**MetroLink**

**Technical Note on Excavated Material**

ML1-JAI-EGN-ROUT\_XX-RP-Y-00009 | P01.1

The purpose of this technical note is to provide an update to Chapter 24 Materials and Waste Management of the EIAR, as requested by the Inspector in the Oral Hearing on 25/02/24 in order to address the following:

Figure 8-6 Northwood Station and Portal Stage 6 - Construction of Roof Slab

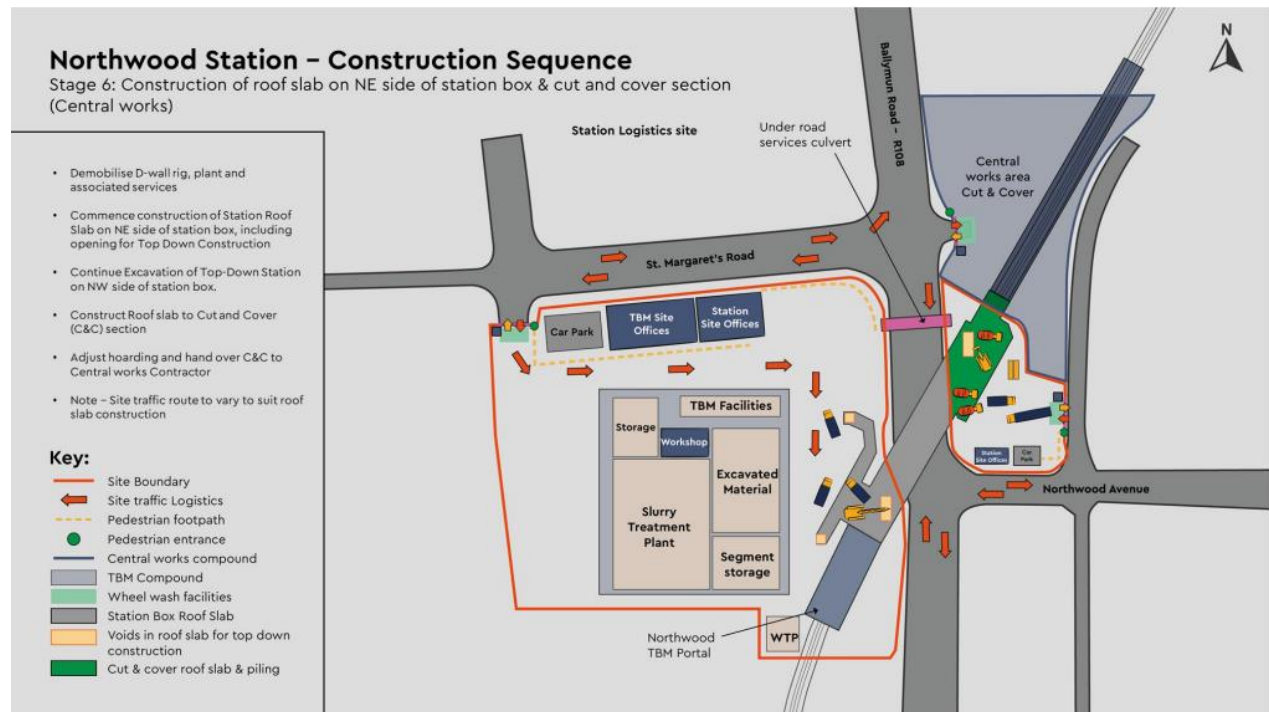
This section provides a response to queries raised by Lidl Ireland GmbH, about waste management activities taking place on their site in respect of excavated materials.

At Stage 6 (see figure below) of the construction excavation of the station box will take place on the east side of Ballymun Road – R108 on Lidl's land. The excavated material will be removed from the site however it is envisaged that there may be some temporary storage for no more than 5 days, to accommodate onward logistics. Excavated material from the TBM will not be stored on Lidl owned land.
